Subject: TAPPING NOISE WHERE EDGE OF DASHBOARD MEETS WINDSHIELD	Bulletin No: 09-004/13
	Last Issued: 03/06/2013

2013 CX-5 vehicles with VINs JM3KE*****122583 ~ 146712 (produced May 6, 2012 ~ Aug. 31, 2012)

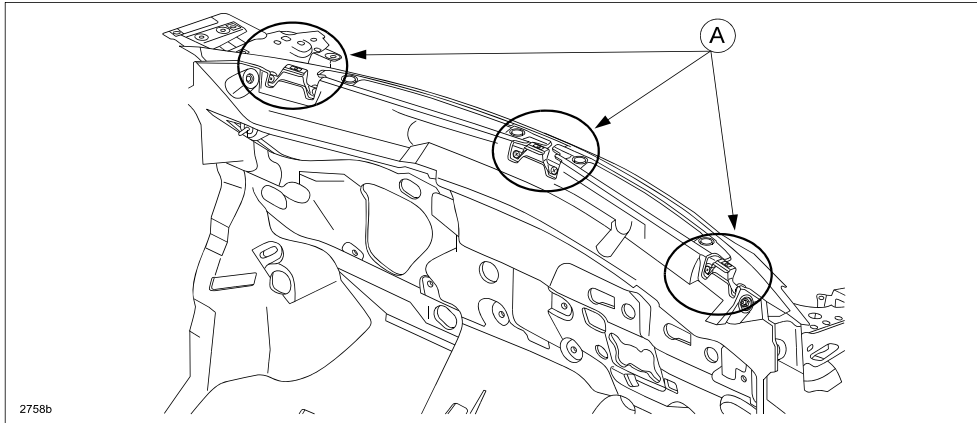
Some vehicles may exhibit a tapping noise which is audible from the front edge of the dashboard (A) (where it meets the base of the windshield) when driving over bumps or rough roads.

The tapping noise may be caused when the front edge of the dashboard contacts the body-side bracket(s). To eliminate the noise, felt pads have been attached to all (3) three body-side brackets during vehicle mass-production.

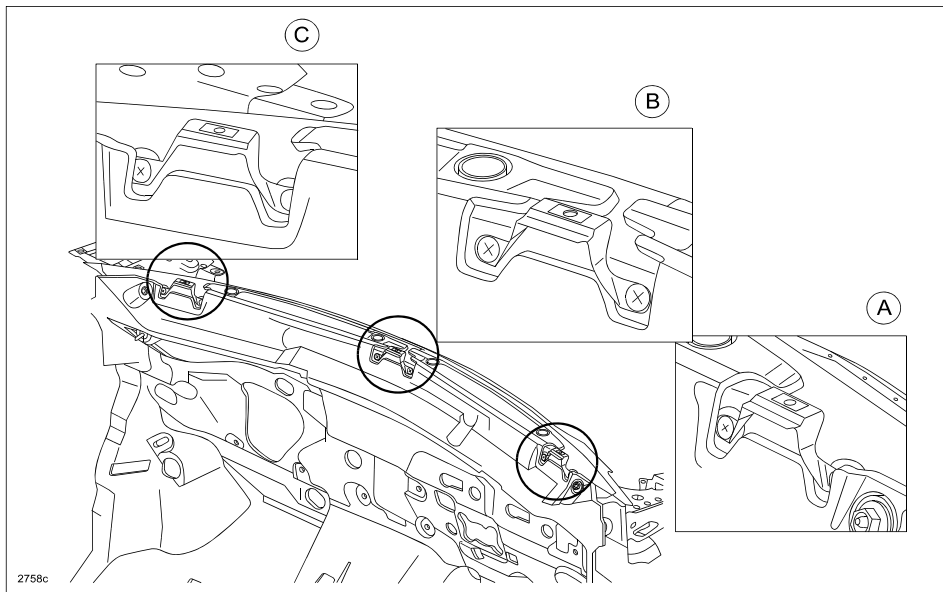
There are (3) three brackets (left, center and right) on the body-side as shown below (A). A felt pad is attached to each bracket for noise prevention. However, depending on the VIN and production date of the vehicle, felt pads may or may not have been attached to all three brackets. Vehicles without felt pads may experience a tapping noise when driving over bumps or rough roads.
